June 30, 2005

Valero Benicia Refinery Plant No. B2626 EPA Comments on Draft Revision 2

**Opacity vs. ESP Amps**

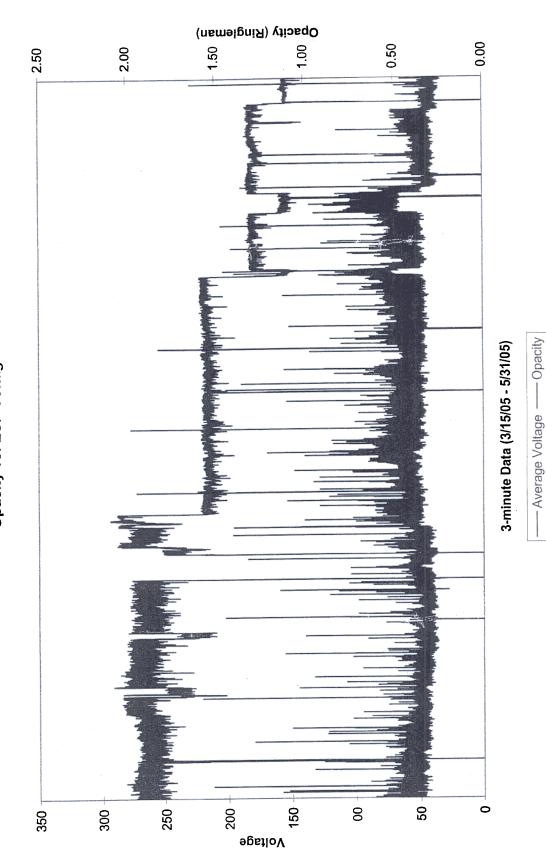
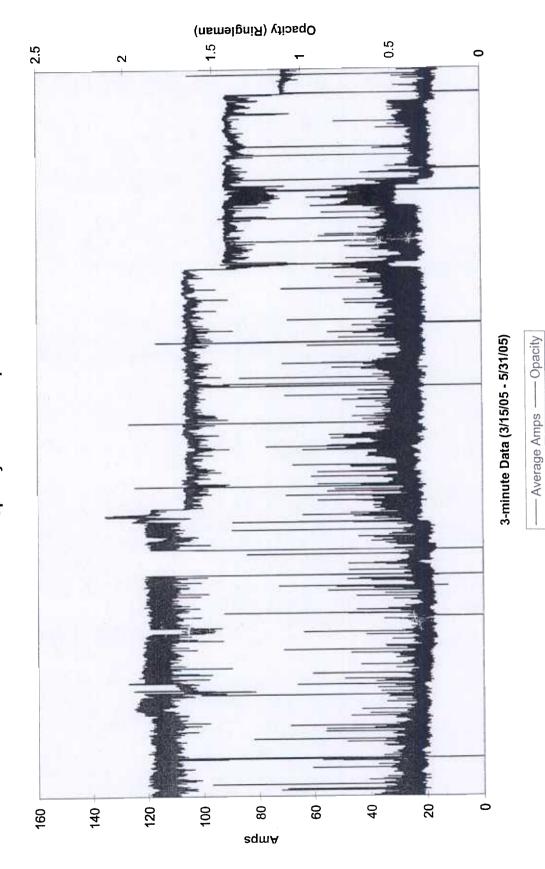
The EPA has expressed interest in requiring refineries to develop a correlation between ESP voltage and current to predict particulate grain loading of flue gas. In discussion with BAAQMD, Valero has asserted that no mathematically significant correlation exists between these variables. Consequently, a parametric monitor based on a flawed correlation would not provide a sound basis for monitoring compliance. Valero asserts that many other process and operating variables combined have a far greater effect on the particulate grain loading of the flue gas.

In most refinery settings, ESPs are part of a complex equipment system. At Valero Benicia Refinery, Coker and FCCU flue gases are combined and combusted in the crude unit (CO) furnaces. Ammonia is injected for NOx control and flue gas conditioning to improve ESP particulate recovery. The flue gases leaving the CO furnaces are combined in common ductwork leading to five parallel ESPs. Downstream of the ESPs, the flue gas is recombined into common ductwork and is discharged via the main stack. The Opacity CEM is located on the main stack and measures the combined stream. The attached graphs compare 3-minute data for ESP voltage and current with opacity for the time period March 15, 2005 through May 31, 2005. In the graphs, opacity is used as a proxy for grain loading and over 37,000 discrete data points for opacity, and 370,000 discrete data points for voltage are reflected. (Note: each ESP has two fields with two voltage readings, resulting in 20 values for the system. This amount of data exceeded the graphing capability of Excel. A simplifying step was taken by showing the average voltage across all ESPs for the purposes of this discussion. Examining the individual voltages shows even more voltage variation during periods of nearly constant opacity, which more dramatically proves the point that no correlation exists.)

The graphs demonstrate that during periods of relatively constant electrical performance, opacity spikes can and do occur. Conversely, during periods of relatively constant opacity, considerable voltage or current variations occur. These data would be characterized as "shotgun" in terms of their statistical significance, and no meaningful correlation exists.

Therefore, no meaningful parametric monitoring option exists using voltage and current as a proxy for particulate grain loading.
